S4.55 MODIFICATION - LIST OF CHANGES

DWG NO.	ARCHITECTURAL DRAWING NAME	ISSUE	REVISION	DATE ISSUED
GENERAL				
DA.1	TITLE PAGE & ROOF/SITE PLAN	MOD	L	11.08.2025
DA.2	EXISTING LOWER GROUND FLOOR DEMOLITION PLAN			
DA.3	EXISTING GROUND FLOOR DEMOLITION PLAN			
DA.4	EXISTING FIRST FLOOR DEMOLITION PLAN			
DA.5	EXISTING ROOF TERRACE DEMOLITION PLAN			
DA.6	PROPOSED LOWER GROUND FLOOR PLAN			
DA.7	PROPOSED GROUND FLOOR PLAN			
DA.8	PROPOSED FIRST FLOOR PLAN			
DA.9	PROPOSED ROOF TERRACE PLAN [AS IS]			
DA.10	SECTION X-X & Y-Y			
DA.11	NORTH & WEST ELEVATIONS			
DA.12	SOUTH & EAST ELEVATIONS			
~~DA.13~~	~~NEW VEHICLE CROSSING PLAN & SECTION~~			
A.100	AREA CALCULATION PLANS			
LA.001	LANDSCAPE PLANS

DRAWING STATUS:
MODIFICATION APPLICATION

HOUSE DELANEY
Alterations & Additions to Existing House
BCA Class 1a
39 Heathcliff Crescent, Balgowlah Heights
Lot 16 Sec 25 D.P. #758044
SITE AREA 617.4m²

PROPOSED
Lower Ground Floor Plan
SCALE 1:100/A2

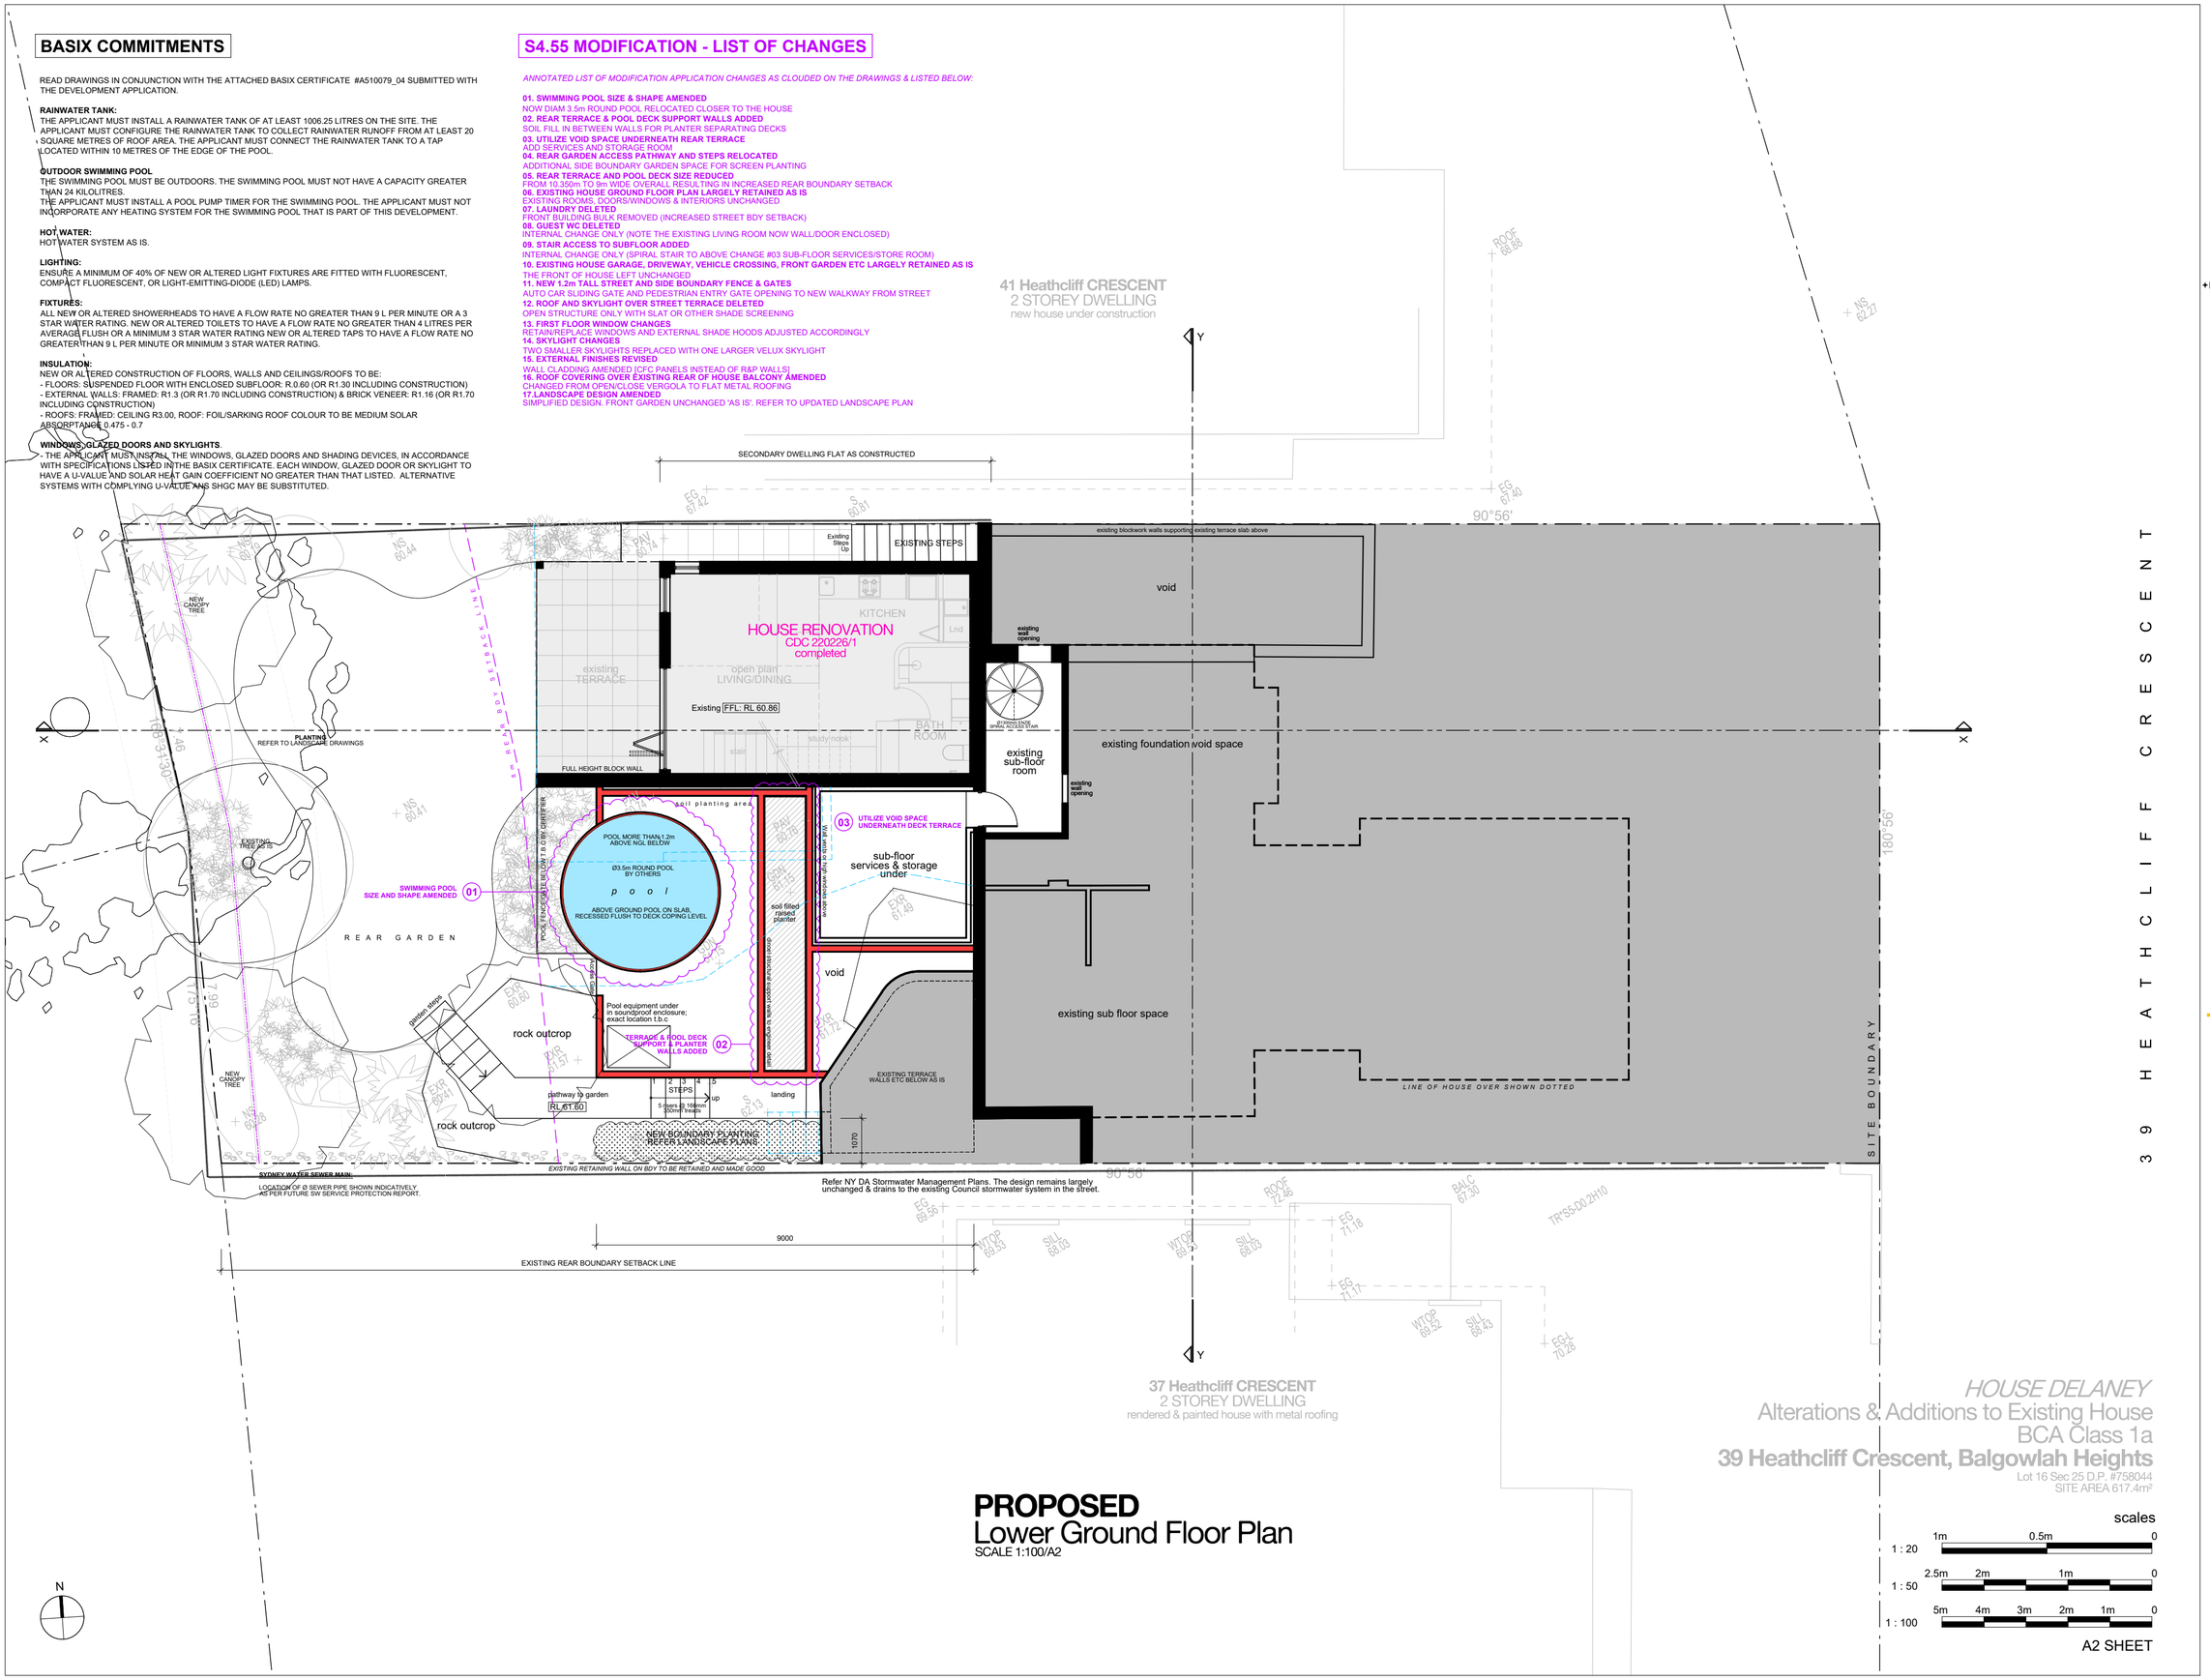
01. SWIMMING POOL SIZE & SHAPE AMENDED
NOW DIAM 3.5m ROUND POOL RELOCATED CLOSER TO THE HOUSE
02. REAR TERRACE & POOL DECK SUPPORT WALLS ADDED
SOIL FILL IN BETWEEN WALLS FOR PLANTER SEPARATING DECKS

03. UTILIZE VOID SPACE UNDERNEATH REAR TERRACE
ADD SERVICES AND STORAGE ROOM
04. REAR GARDEN ACCESS PATHWAY AND STEPS RELOCATED
ADDITIONAL SIDE BOUNDARY GARDEN SPACE FOR SCREEN PLANTING

05. REAR TERRACE AND POOL DECK SIZE REDUCED
FROM 10.350m TO 9m WIDE OVERALL RESULTING IN INCREASED REAR BOUNDARY SETBACK
06. EXISTING HOUSE GROUND FLOOR PLAN LARGELY RETAINED AS IS
EXISTING ROOMS, DOORS/WINDOWS & INTERIORS UNCHANGED

07. LAUNDRY DELETED
FRONT BUILDING BULK REMOVED (INCREASED STREET BDY SETBACK)
08. GUEST WC DELETED
INTERNAL CHANGE ONLY (NOTE THE EXISTING LIVING ROOM NOW WALL/DOOR ENCLOSED)

09. STAIR ACCESS TO SUBFLOOR ADDED
INTERNAL CHANGE ONLY (SPIRAL STAIR TO ABOVE CHANGE #03 SUB-FLOOR SERVICES/STORE ROOM)
10. EXISTING HOUSE GARAGE, DRIVEWAY, VEHICLE CROSSING, FRONT GARDEN ETC LARGELY RETAINED AS IS
THE FRONT OF HOUSE LEFT UNCHANGED

PROPOSED
Ground Floor Plan
SCALE 1:100/A2

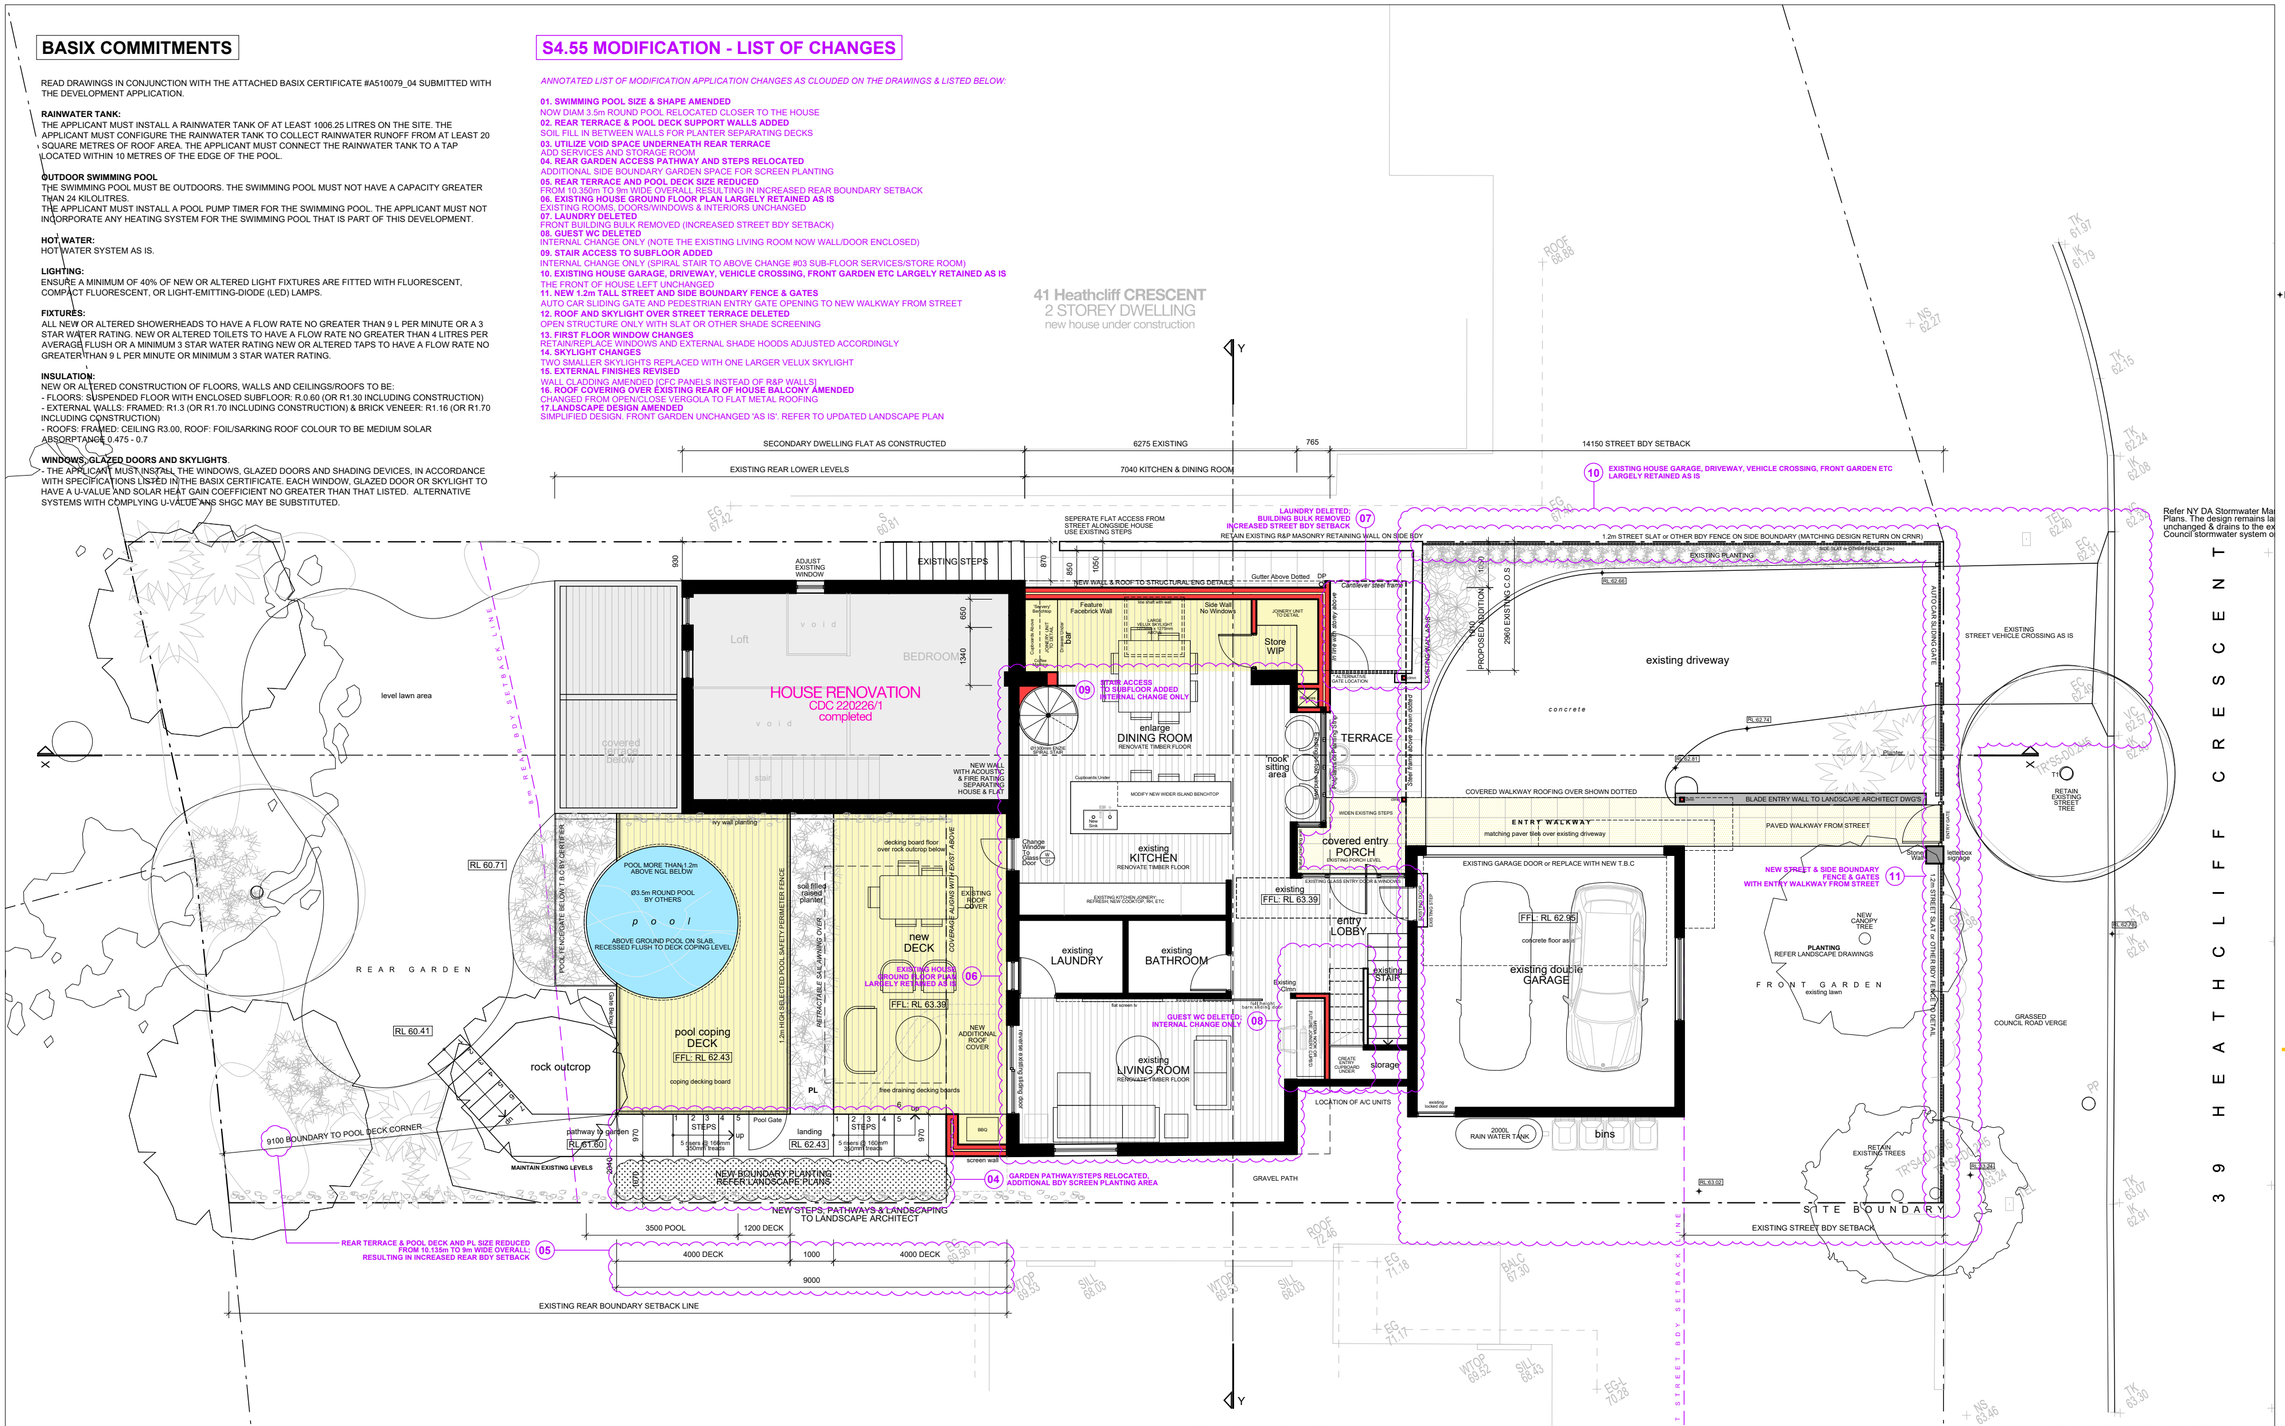
01. SWIMMING POOL SIZE & SHAPE AMENDED
NOW DIAM 3.5m ROUND POOL RELOCATED CLOSER TO THE HOUSE
02. REAR TERRACE & POOL DECK SUPPORT WALLS ADDED
SOIL FILL IN BETWEEN WALLS FOR PLANTER SEPARATING DECKS

03. UTILIZE VOID SPACE UNDERNEATH REAR TERRACE
ADD SERVICES AND STORAGE ROOM
04. REAR GARDEN ACCESS PATHWAY AND STEPS RELOCATED
ADDITIONAL SIDE BOUNDARY GARDEN SPACE FOR SCREEN PLANTING

05. REAR TERRACE AND POOL DECK SIZE REDUCED
FROM 10.350m TO 9m WIDE OVERALL RESULTING IN INCREASED REAR BOUNDARY SETBACK
06. EXISTING HOUSE GROUND FLOOR PLAN LARGELY RETAINED AS IS
EXISTING ROOMS, DOORS/WINDOWS & INTERIORS UNCHANGED

07. LAUNDRY DELETED
FRONT BUILDING BULK REMOVED (INCREASED STREET BDY SETBACK)
08. GUEST WC DELETED
INTERNAL CHANGE ONLY (NOTE THE EXISTING LIVING ROOM NOW WALL/DOOR ENCLOSED)

09. STAIR ACCESS TO SUBFLOOR ADDED
INTERNAL CHANGE ONLY (SPIRAL STAIR TO ABOVE CHANGE #03 SUB-FLOOR SERVICES/STORE ROOM)
10. EXISTING HOUSE GARAGE, DRIVEWAY, VEHICLE CROSSING, FRONT GARDEN ETC LARGELY RETAINED AS IS
THE FRONT OF HOUSE LEFT UNCHANGED
